Re: EPA Advice on HVO: Second Submission - HVO North and South Open Cut Coal Continuation Projects (SSD-11826681 and SSD-11826621) - EPA Comments to Submissions Report

I refer to Department of Planning, Housing, and Infrastructure's (DPHI) two Request for Information (RFI) letters dated 14 June 2024 received in relation to HVO North (SSD 11826681) and HVO South (SSD-11826621).

Figure 1 HVO Project Scope 1 Emissions Profile and Indicative Baselines²

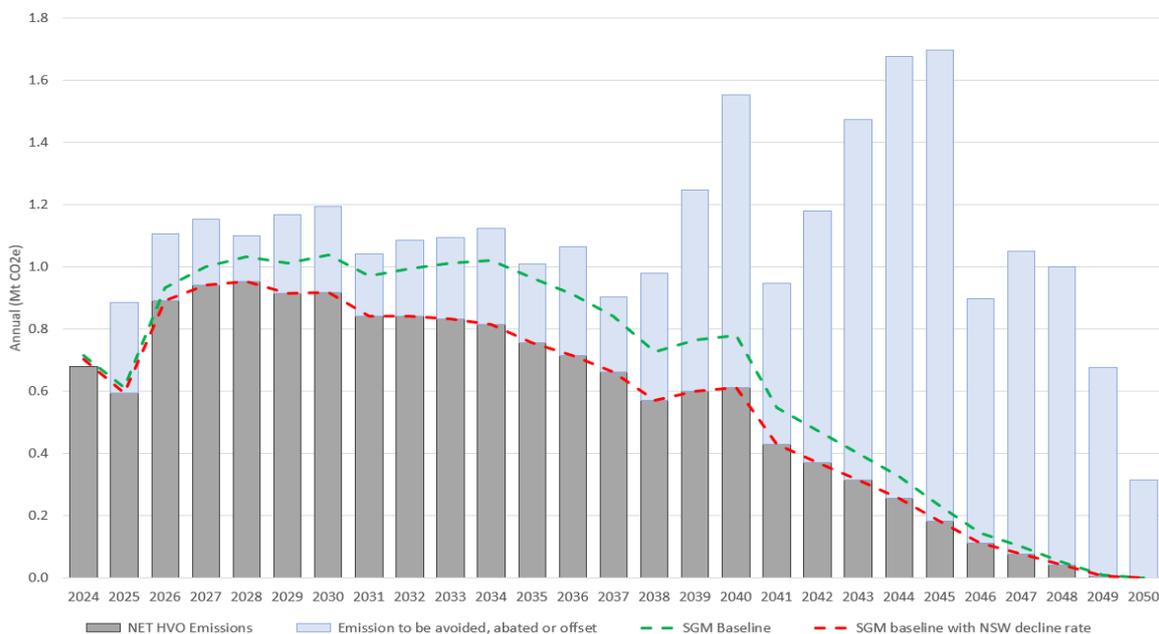
The EPA acknowledges this commitment however subsequently discusses HVO’s gross emissions, including comparison to NSW gross emissions, without consideration of HVO’s net emissions commitment. Whilst HVO has modelled gross emissions without avoidance for transparency, it must be noted the cost of offsets considered to meet the proposed baseline will be significant and will drive HVO to consider avoidance, reduction, or substitution before offsetting for fundamental business economic reasons. Therefore, to be clear, HVO is committing to the net emissions as per the adjusted SGM baseline proposed shown below in **Figure 1** (red dashed line).
